Fairhope Planning Commission Agenda

October 6, 2025 – 5:00 PM

SR 25.05 - Wendy's

SR 25.07 - Advanced Auto Parts

Proposed Site Plan

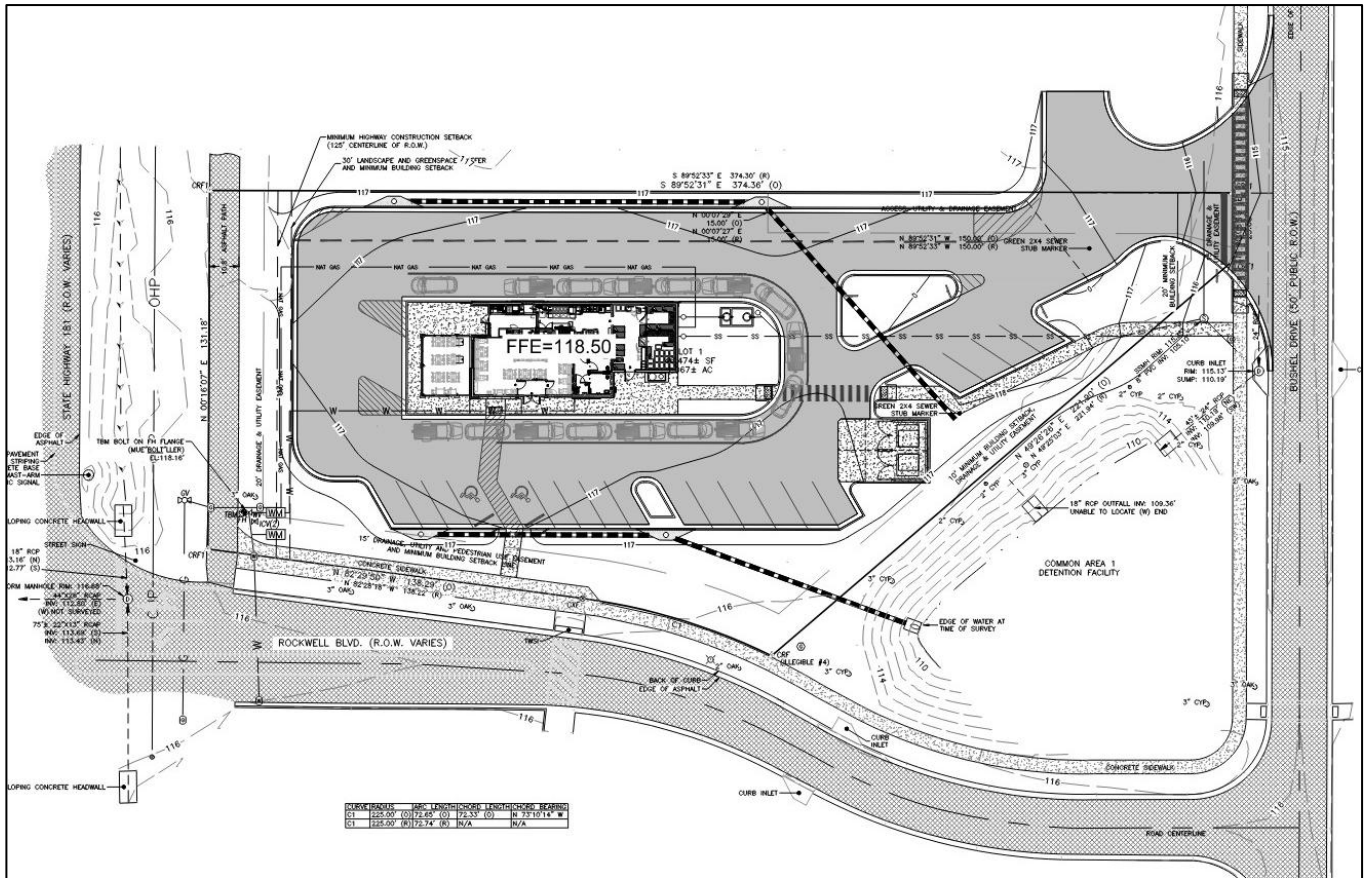
The site plan illustrates a surplus of parking with an acceptable 19 spaces. Twenty percent (20%) overage is allowed and is required to utilize pervious surfacing in accordance with Article IV Section E.4.c(2) of the Zoning Ordinance. The site plan does not provide any pervious parking spaces; whereas at least three (3) need to be pervious. There are six (6) compact parking spaces.

The site plan includes interior concrete sidewalks along Bushel Drive and Rockwell Boulevard. The concrete sidewalk also connects with an existing asphalt path parallel to State Highway 181. The Pedestrian Circulation Plan can be found on Sheet C8.0 in the Complete Plans.

1. Revision of the Site Plan to include pervious parking in compliance with Article IV Section E.4.c(2) of the Zoning Ordinance ;
2. Coordination with City Horticulturalist on submittal of a compliant tree and landscaping plan; and
3. All signage shall conform to the City of Fairhope Sign Ordinance.
